*Preliminary Consultation*  
**MONTGOMERY COUNTY HISTORIC PRESERVATION COMMISSION**  
**STAFF REPORT**

<b>Address:</b>	102 East Kirke Street, Chevy Chase	<b>Meeting Date:</b>	4/17/2024
<b>Resource:</b>	Outstanding Resource Chevy Chase Village Historic District	<b>Report Date:</b>	4/10/2024
<b>Applicant:</b>	Britt & Will Williams Luke Olson, Architect	<b>Public Notice:</b>	4/3/2024
<b>Review:</b>	Preliminary Consultation	<b>Staff:</b>	Dan Bruechert
<b>Proposal:</b>	Demolition of garage and construction of new garage, partial demolition, fenestration alteration, new two-story rear addition, hardscape alterations, tree removal, pool installation.

*Figure 3: Existing west elevation showing the one-story addition (circled) and proposed addition and deck, below.*

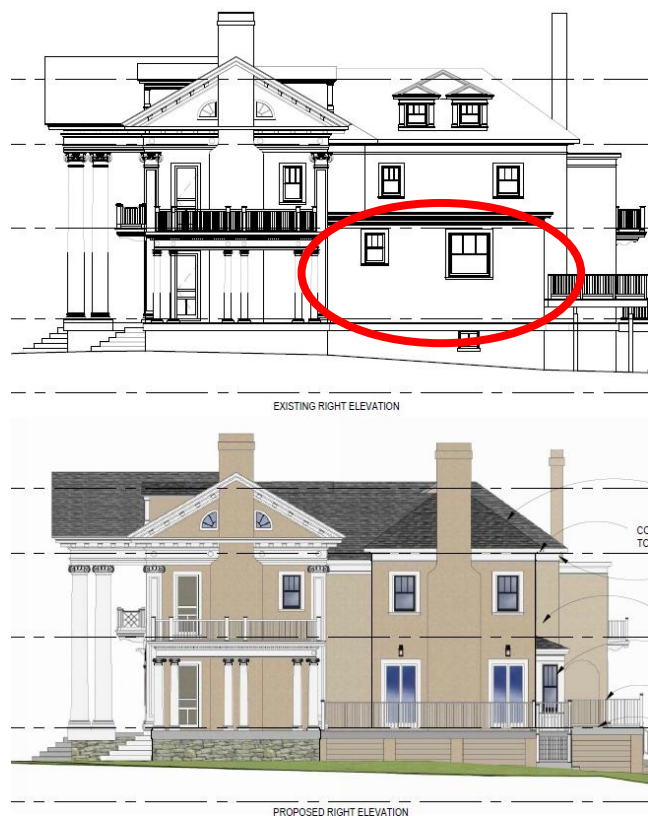
Staff finds the existing rear addition is not original to the date of construction and does not significantly contribute to the architectural significance of the property. Staff finds its demolition will not negatively impact on the character of the property or the surrounding district.

Staff finds the footprint of the proposed addition is wider than the existing two-story ell, but is not as deep and has the same approximate square footage as the existing two-story ell. Because of the large scale of the historic house, Staff does not find the addition will overwhelm the historic house. Staff has some

reservations that the proposed addition will eliminate three historic windows and approach too close to the southwest corner of the house. A typical best practice is set additions far enough from the corner to retain the first bay of windows, thus better preserving the historic outline of the house. However, Staff also notes these windows are on the rear elevation of the house; and the windows lack the trim and other architectural embellishment found on the front and side historic window openings and are therefore less historically significant.

Staff additionally finds the proposed addition's design will not visually compete with the highly decorated Neoclassical Revival architecture of the historic house. Staff finds additional architectural embellishments may be appropriate to better tie the new construction to the historic house. The proposed materials consisting of stucco siding, multi-light sash windows, and asphalt shingle roofing are all consistent with the historic house and Staff finds are appropriate.

Finally, Staff finds the proposed deck to the west of the addition adds mass to the proposed addition and appears to visually compete with the historic two-story porch. Staff recommends the deck either be eliminated or enlarged so its massing is more compatible with the historic. This porch could be a simplified version of the two-story porch.

- Is it appropriate to cover the three historic windows on the rear elevation?
- Does the HPC concur with Staff that the proposed addition should be revised to better tie the historic house to the proposed addition?
- Does the HPC concur with Staff that the design of the proposed composite side porch needs to be revised to be more compatible with the existing side porch or eliminated?
